Site Accessibility Evaluation

Sahwatch Parking Garage

**255 Sahwatch St
Colorado Springs, CO
80903**

Inspection Date: 08/27/2019

Finding: 1

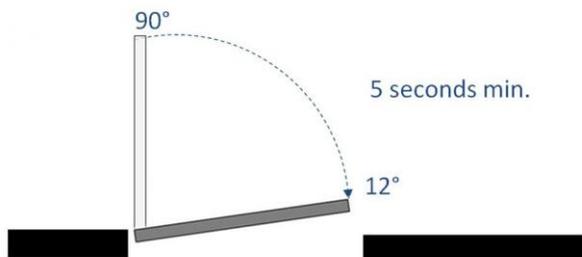
The door is equipped with a door closer and returns to a closed position too quickly.

2.5 seconds to closed position

Adjust door closer to allow a minimum of 5 seconds before returning to a position of 12 degrees from the latch/locking mechanism.

Finding: 3

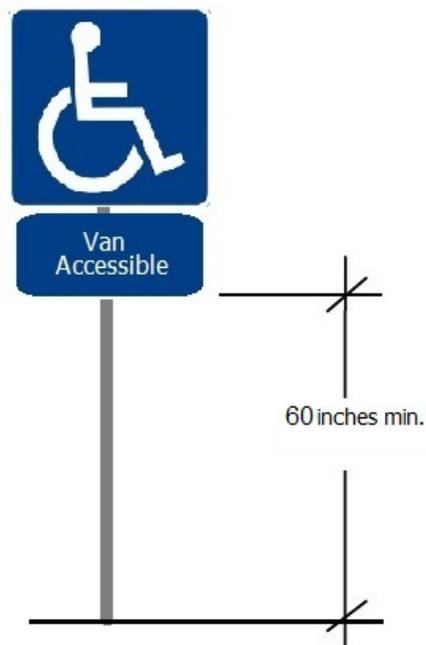
The parking sign is mounted too low.

39.5 inches above finished floor

Ensure new ISA van sign is placed no lower than 60 inches minimum measured from the bottom edge of the sign above the finished floor.

Finding: 4

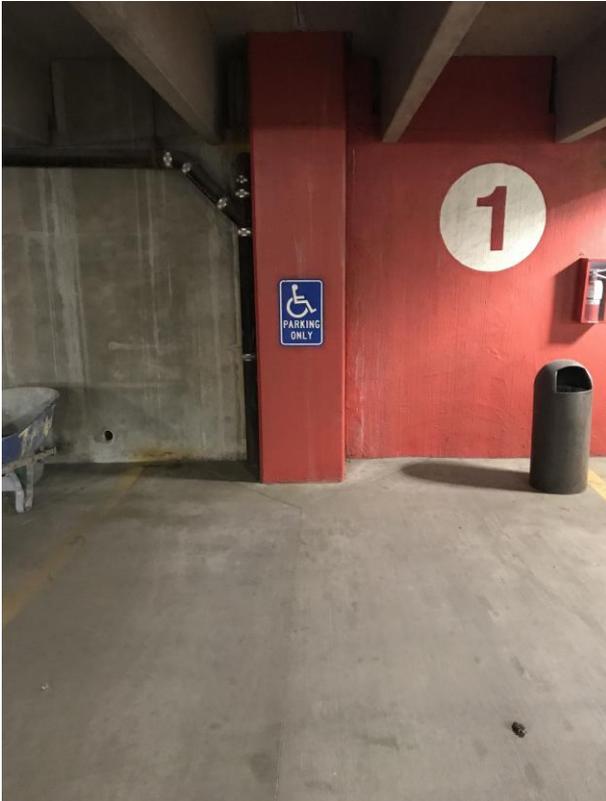
The van stall is missing a sign identifying it as a van accessible stall.

Van accessible sign missing

Replace existing sign with ISA sign that also includes "Van Accessible" verbiage.

Finding: 5

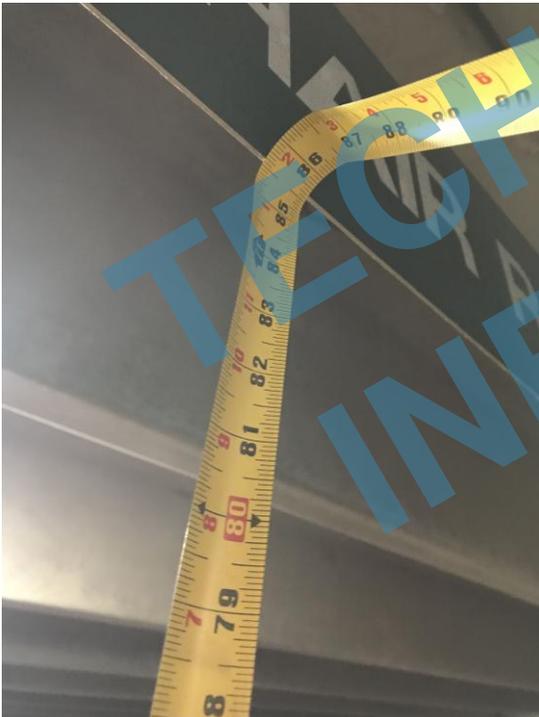
The vehicle route to the accessible parking contains vertical clearances less than 98 inches.

85.5 inches above
finish floor

Providing the minimum required height clearance to the parking structure is technically infeasible at this time because existing structural conditions would require removing or altering a load-bearing member that is an essential part of the structural frame; or because other existing physical or site constraints prohibit modification or addition of elements, spaces, or features that are in full and strict compliance with the minimum requirements. Best practice measures are recommended to ensure parking structure is accessible to the maximum extent possible.

Finding: 6

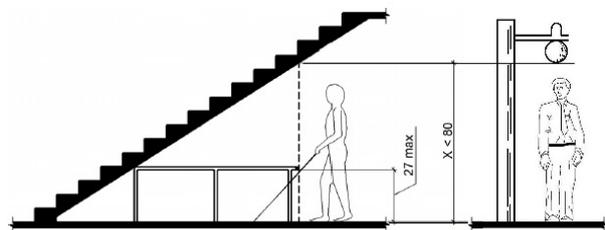
The "Stair to 1 West" overhanging sign extends down too close to the route of travel.

75.5 inches above finished floor

Adjust overhanging sign to provide a minimum of 80 inches above the walking surface measured from the bottom edge of the sign.

Finding: 7

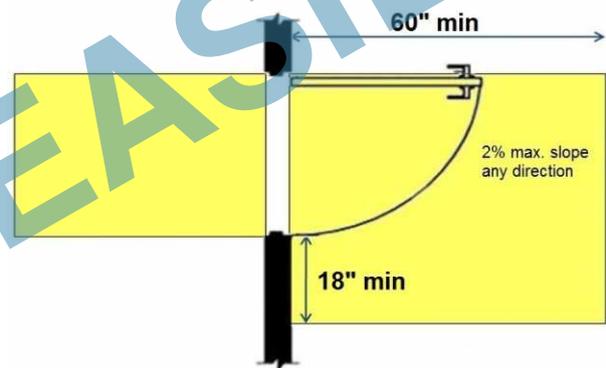
The maneuvering space on the pull side of the door or gate does not adequately extend beyond the latch side of the door.

12 inches of maneuvering space on the pull side

Providing the minimum required maneuvering space on the pull side of the door is technically infeasible at this time because existing structural conditions would require removing or altering a load-bearing member that is an essential part of the structural frame; or because other existing physical or site constraints prohibit modification or addition of elements, spaces, or features that are in full and strict compliance with the minimum requirements. Best practice measures are recommended to ensure parking garage is accessible to the maximum extent possible.

Finding: 10

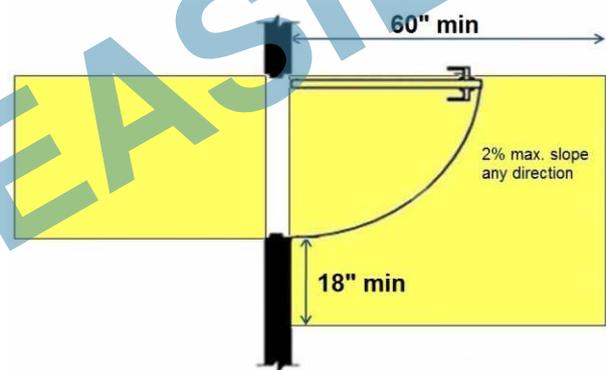
The maneuvering space on the pull side of the door or gate does not adequately extend beyond the latch side of the door.

12 inches of maneuvering space on the pull side

Providing the minimum required maneuvering space on the pull side of the door is technically infeasible at this time because existing structural conditions would require removing or altering a load-bearing member that is an essential part of the structural frame; or because other existing physical or site constraints prohibit modification or addition of elements, spaces, or features that are in full and strict compliance with the minimum requirements. Best practice measures are recommended to ensure parking garage is accessible to the maximum extent possible.

Finding: 11

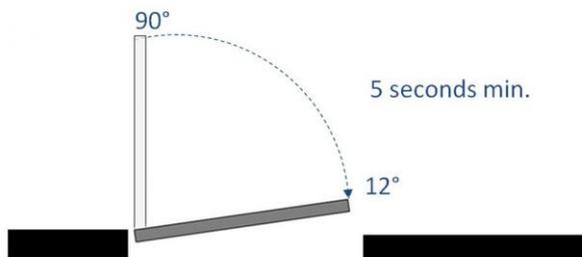
The door is equipped with a door closer and returns to a closed position too quickly.

3.63 seconds to closed position

Adjust door closer to allow a minimum of 5 seconds before returning to a position of 12 degrees from the latch/locking mechanism.

Finding: 14

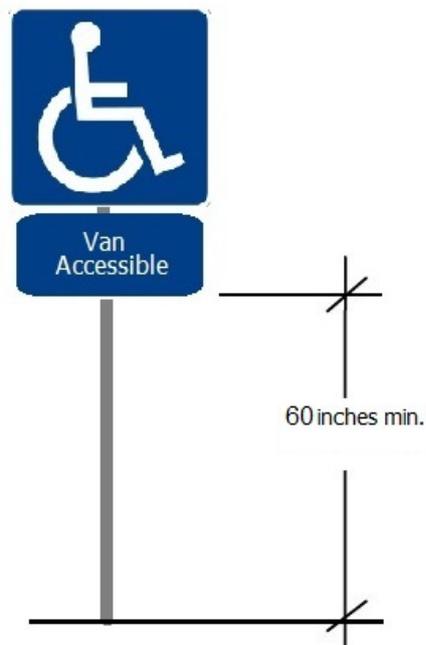
The parking sign is mounted too low.

44.5 inches above finished floor

Ensure new ISA van sign is placed no lower than 60 inches minimum measured from the bottom edge of the sign above the finished floor.

Finding: 15

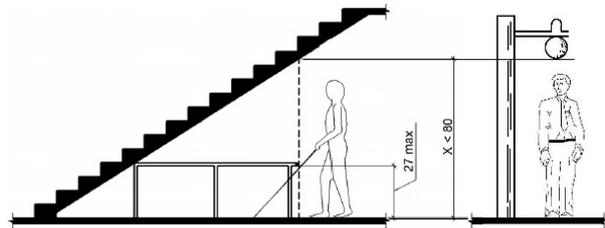
The “Stair to 2 West” overhanging sign extends down too close to the route of travel.

77 inches above finished floor

Adjust overhanging sign to provide a minimum of 80 inches above the walking surface measured from the bottom edge of the sign.

Finding: 16

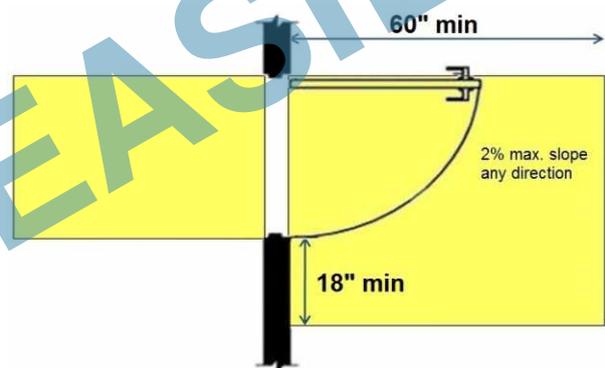
The maneuvering space on the pull side of the door or gate does not adequately extend beyond the latch side of the door.

12 inches of maneuvering space on the pull side

Providing the minimum required maneuvering space on the pull side of the door is technically infeasible at this time because existing structural conditions would require removing or altering a load-bearing member that is an essential part of the structural frame; or because other existing physical or site constraints prohibit modification or addition of elements, spaces, or features that are in full and strict compliance with the minimum requirements. Best practice measures are recommended to ensure parking garage is accessible to the maximum extent possible.

Finding: 17

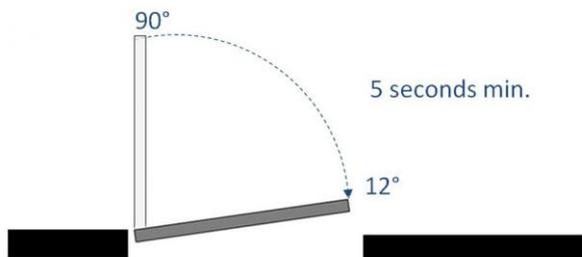
The door is equipped with a door closer and returns to a closed position too quickly.

2.5 seconds to closed position

Adjust door closer to allow a minimum of 5 seconds before returning to a position of 12 degrees from the latch/locking mechanism.

Finding: 19

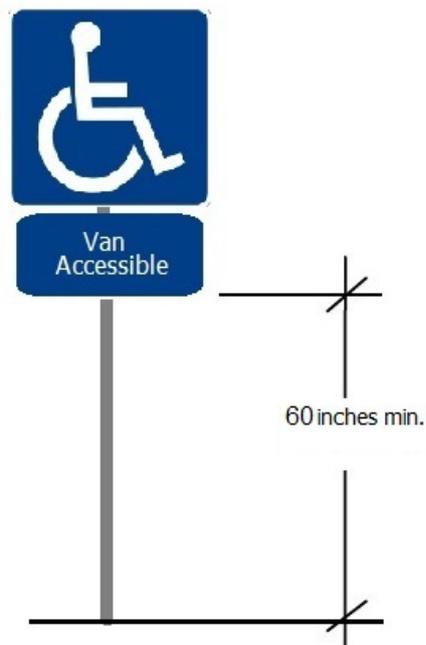
The parking sign is mounted too low.

38.75 inches above finished floor

Ensure new ISA van sign is placed no lower than 60 inches minimum measured from the bottom edge of the sign above the finished floor.

Finding: 21

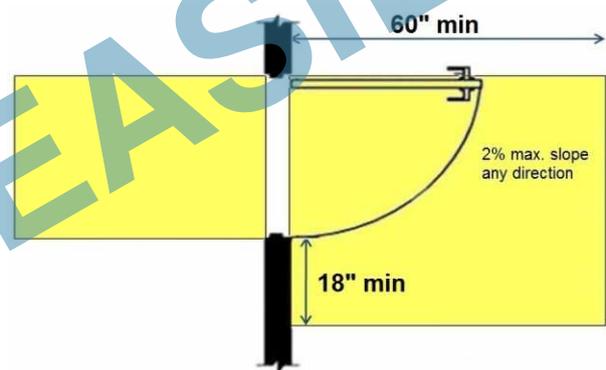
The maneuvering space on the pull side of the door or gate does not adequately extend beyond the latch side of the door.

12 inches of maneuvering space on the pull side

Providing the minimum required maneuvering space on the pull side of the door is technically infeasible at this time because existing structural conditions would require removing or altering a load-bearing member that is an essential part of the structural frame; or because other existing physical or site constraints prohibit modification or addition of elements, spaces, or features that are in full and strict compliance with the minimum requirements. Best practice measures are recommended to ensure parking garage is accessible to the maximum extent possible.

Finding: 22

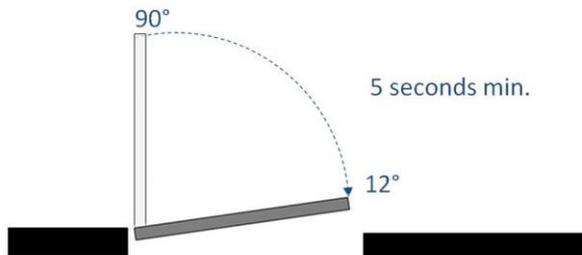
The door is equipped with a door closer and returns to a closed position too quickly.

3.2 seconds to closed position

Adjust door closer to allow a minimum of 5 seconds before returning to a position of 12 degrees from the latch/locking mechanism.

Finding: 25

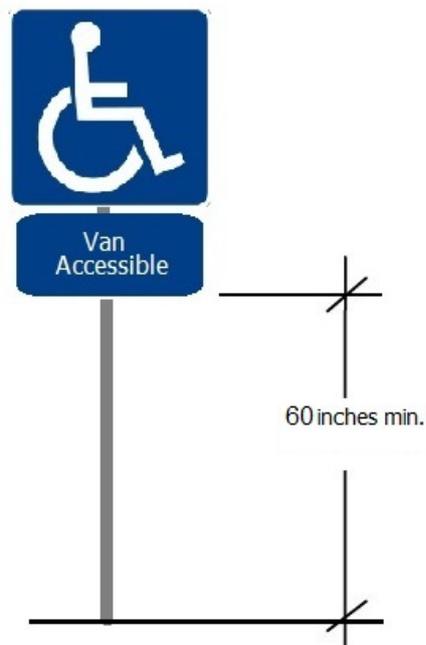
The parking sign is mounted too low.

40.75 inches above finished floor

Ensure new ISA van sign is placed no lower than 60 inches minimum measured from the bottom edge of the sign above the finished floor.

Finding: 26

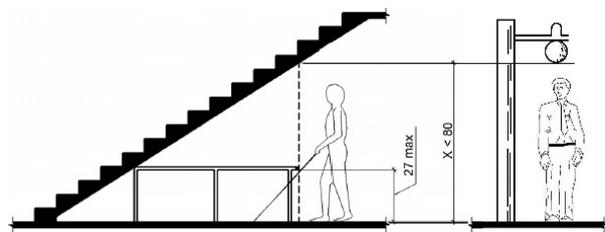
The “Stair to 3 West” overhanging sign extends down too close to the route of travel.

76 inches above finished floor

Adjust overhanging sign to provide a minimum of 80 inches above the walking surface measured from the bottom edge of the sign.

Finding: 27

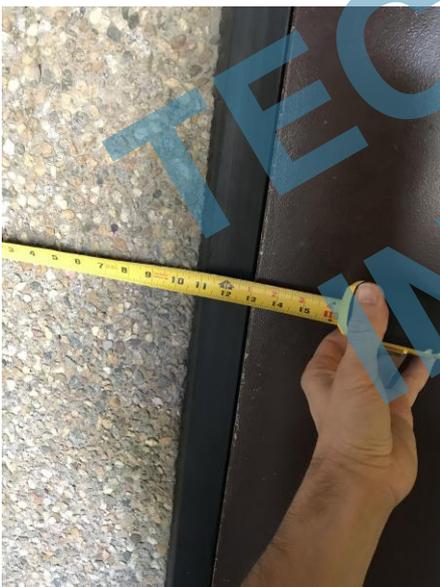
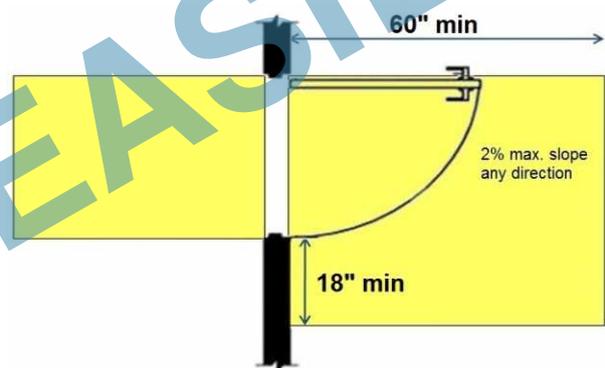
The maneuvering space on the pull side of the door or gate does not adequately extend beyond the latch side of the door.

13 inches of maneuvering space on the pull side

Providing the minimum required maneuvering space on the pull side of the door is technically infeasible at this time because existing structural conditions would require removing or altering a load-bearing member that is an essential part of the structural frame; or because other existing physical or site constraints prohibit modification or addition of elements, spaces, or features that are in full and strict compliance with the minimum requirements. Best practice measures are recommended to ensure parking garage is accessible to the maximum extent possible.

Finding: 30

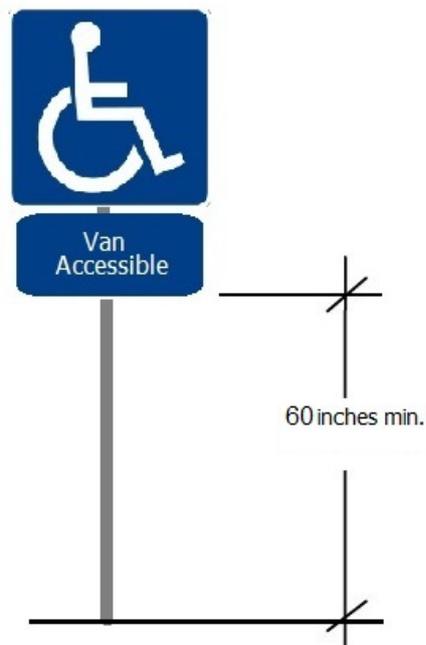
The parking sign is mounted too low.

33.5 inches above finished floor

Ensure new ISA van sign is placed no lower than 60 inches minimum measured from the bottom edge of the sign above the finished floor.

Finding: 31

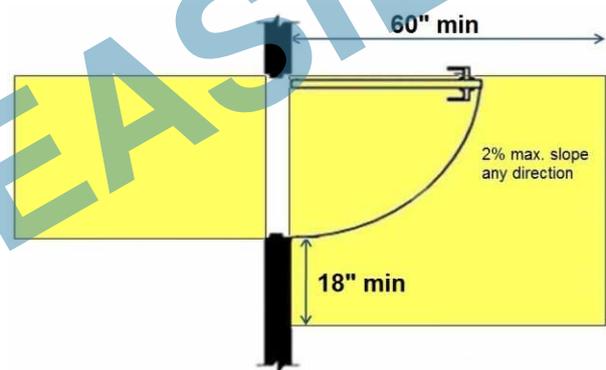
The maneuvering space on the pull side of the door or gate does not adequately extend beyond the latch side of the door.

13 inches of maneuvering space on the pull side

Providing the minimum required maneuvering space on the pull side of the door is technically infeasible at this time because existing structural conditions would require removing or altering a load-bearing member that is an essential part of the structural frame; or because other existing physical or site constraints prohibit modification or addition of elements, spaces, or features that are in full and strict compliance with the minimum requirements. Best practice measures are recommended to ensure parking garage is accessible to the maximum extent possible.

Finding: 32

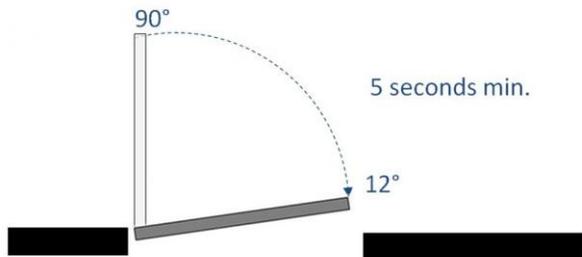
The door is equipped with a door closer and returns to a closed position too quickly.

3.95 seconds to closed position

Adjust door closer to allow a minimum of 5 seconds before returning to a position of 12 degrees from the latch/locking mechanism.

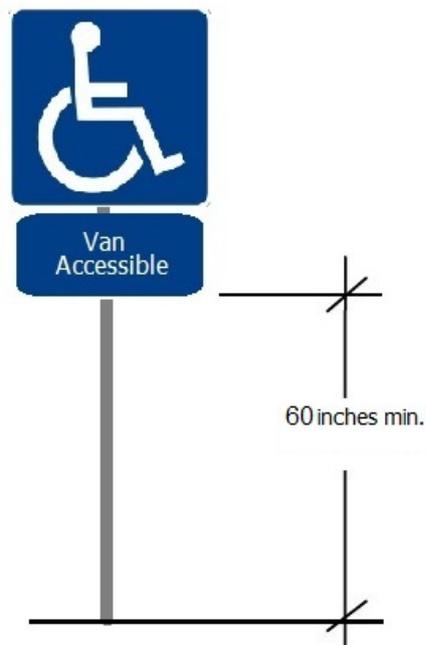
38.25 inches above finished floor

Ensure new ISA van sign is placed no lower than 60 inches minimum measured from the bottom edge of the sign above the finished floor.

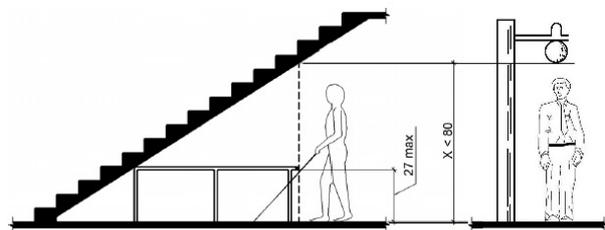
76 inches above finished floor

Adjust overhanging sign to provide a minimum of 80 inches above the walking surface measured from the bottom edge of the sign.

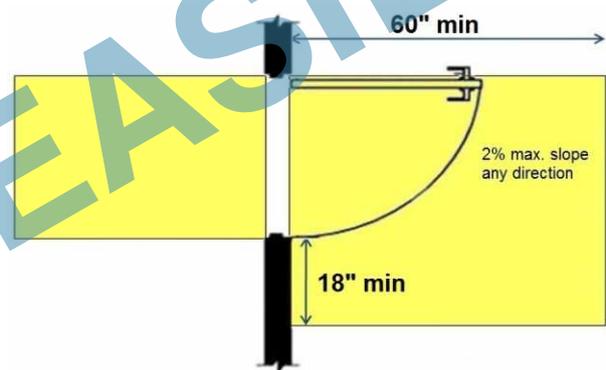
12.5 inches of maneuvering space on the pull side

Providing the minimum required maneuvering space on the pull side of the door is technically infeasible at this time because existing structural conditions would require removing or altering a load-bearing member that is an essential part of the structural frame; or because other existing physical or site constraints prohibit modification or addition of elements, spaces, or features that are in full and strict compliance with the minimum requirements. Best practice measures are recommended to ensure parking garage is accessible to the maximum extent possible.

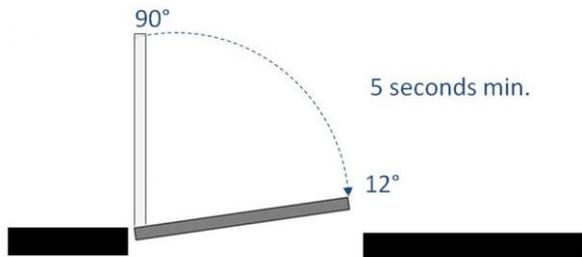
4.3 seconds to closed position

Adjust door closer to allow a minimum of 5 seconds before returning to a position of 12 degrees from the latch/locking mechanism.

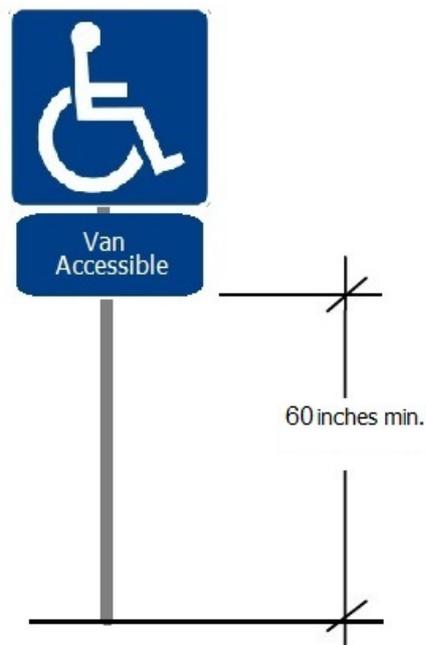
40.25 inches above finished floor

Ensure new ISA van sign is placed no lower than 60 inches minimum measured from the bottom edge of the sign above the finished floor.

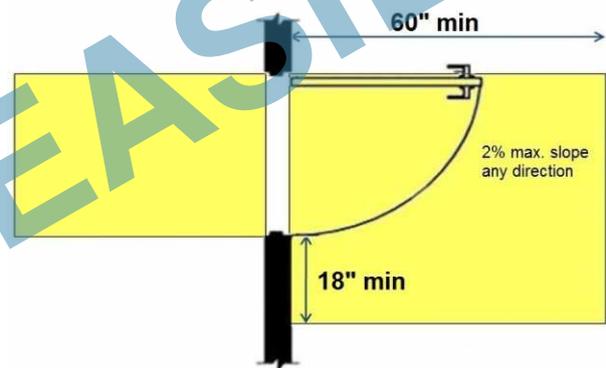
11.5 inches of maneuvering space on the pull side

Providing the minimum required maneuvering space on the pull side of the door is technically infeasible at this time because existing structural conditions would require removing or altering a load-bearing member that is an essential part of the structural frame; or because other existing physical or site constraints prohibit modification or addition of elements, spaces, or features that are in full and strict compliance with the minimum requirements. Best practice measures are recommended to ensure parking garage is accessible to the maximum extent possible.

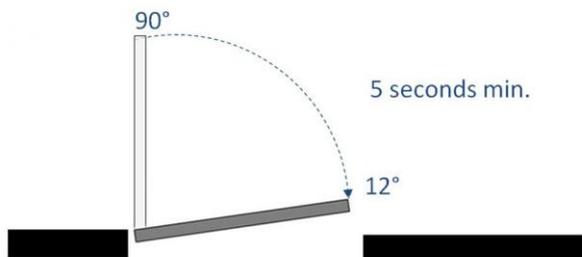
2.4 seconds to closed position

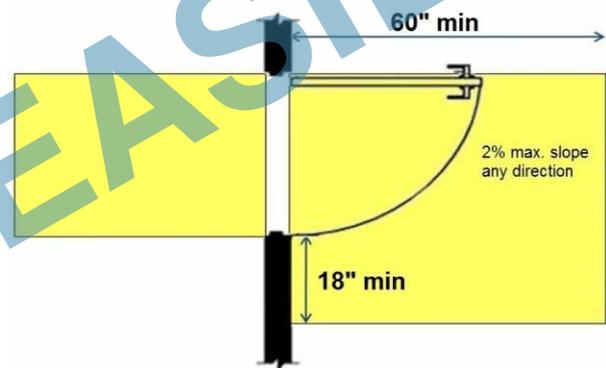
12.5 inches of maneuvering space on the pull side

Providing the minimum required maneuvering space on the pull side of the door is technically infeasible at this time because existing structural conditions would require removing or altering a load-bearing member that is an essential part of the structural frame; or because other existing physical or site constraints prohibit modification or addition of elements, spaces, or features that are in full and strict compliance with the minimum requirements. Best practice measures are recommended to ensure parking garage is accessible to the maximum extent possible.

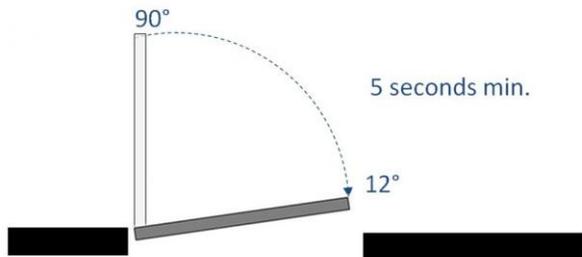
2.1 seconds to closed position

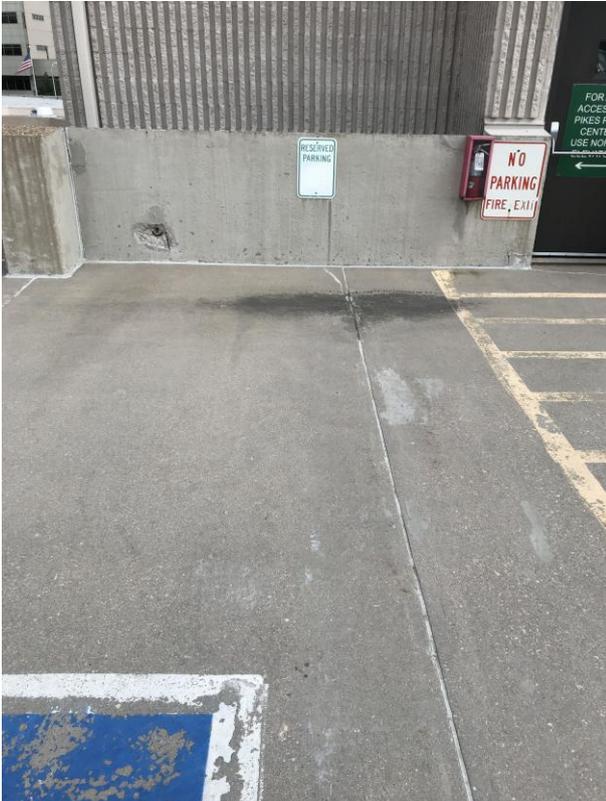
Van accessible sign missing

Replace existing sign with ISA sign that also includes "Van Accessible" verbiage.

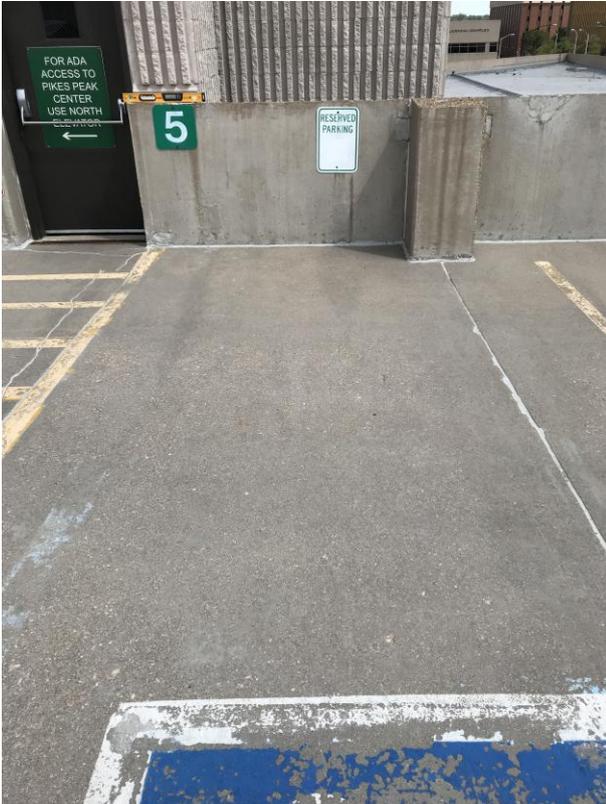
Van accessible sign missing

Replace existing sign with ISA sign that also includes "Van Accessible" verbiage.

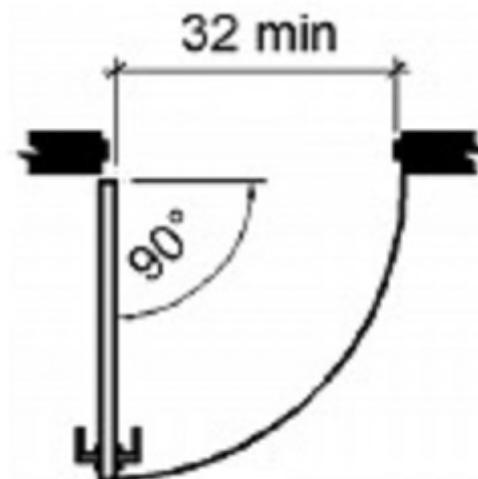
The door opening does not provide at least 32 inches between the face of the door and the opposite stop.

30 inches wide

5th level south door entrance very difficult to open. Adjust hinges/door closer or replace door to provide minimum width clearance of 32 inches into elevator area.
